UNITED STATES PATENT AND TRADEMARK OFFICE

Office Action Summary

10/660,145

BERNBAUM ET AL.

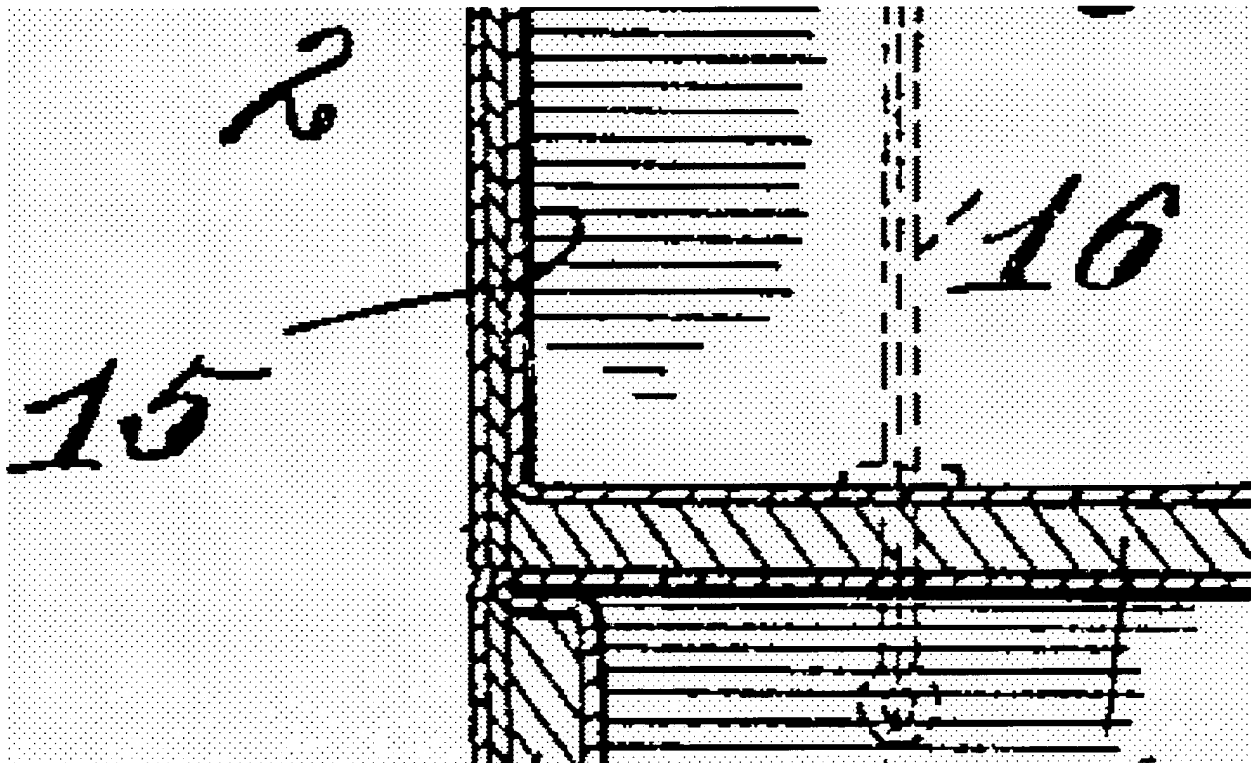
6. Claims 1-4, 10-12, and 15 are rejected under 35 U.S.C. 103(a) as being unpatentable over Tinderman (792183) in view of Rekuc et al. (5435423). Tiderman teaches a soft-sided carrying case comprising a primary compartment defined by the interior of portion 15, the primary compartment including a plurality of sidewalls, a top wall (it is noted that applicant defines the top wall broadly, i.e., the top wall comprises the narrow portions 12 f surrounding at least a portion of the top. In this case, Tinderman teaches a top narrow portion above portion 5) and a

bottom wall, a first one of the sidewalls and a second one of the sidewalls each formed of a flexible fabric material including an extended portion, a first upper compartment defined by the interior of portion 15, the first upper compartment having a plurality of sidewalls, a top wall, and a bottom wall, one of the sidewalls of the first upper compartment being formed of the same contiguous piece of flexible fabric material as the first sidewall of the primary compartment, the sidewall of the first upper compartment and the first sidewall of the primary compartment defining a first hinge line generally adjacent to an interface defined between the primary compartment and the first upper compartment, the first hinge line permitting the first upper compartment to pivot about the first hinge line between a folded position and an unfolded position; and a second upper compartment, the second upper compartment having a plurality of sidewalls, a top wall, and a bottom wall, one of the sidewalls of the second upper compartment being formed of the same contiguous piece of flexible fabric material as the second sidewall of the primary compartment (see drawing below and note the compartments being formed of the same contiguous piece of the outer layer), the sidewall of the second upper compartment and the first sidewall of the primary compartment defining a second hinge line generally adjacent to an interface defined between the primary compartment and the second upper compartment, the second hinge line permitting the second upper compartment to pivot about the second hinge line between a folded position and an unfolded position. Tiderman meets all claimed limitations except for the carrying case including a pair of wheels and an extendable handle.

Rekuc teaches that it is known in the art to provide a luggage with a wheels and an extendable handle. It would have been obvious to one of ordinary skill in the art to provide wheels and an extendable handle in Tiderman as taught by Rekuc to move the luggage easily.

Regarding claims 3-4, note the straps 23 in Tiderman.

Regarding claim 15, it would have been obvious to one of ordinary skill in the art to eliminate the hinges 16 to have the hinge exclusive provided by the extensions of the sidewalls. since it is obvious for one of ordinary skill in this art to eliminate the extra hinge when its function is not desired. See, Ex parte Rainu, 168 USPQ 375 (PTO Bd. Of App. 1969).
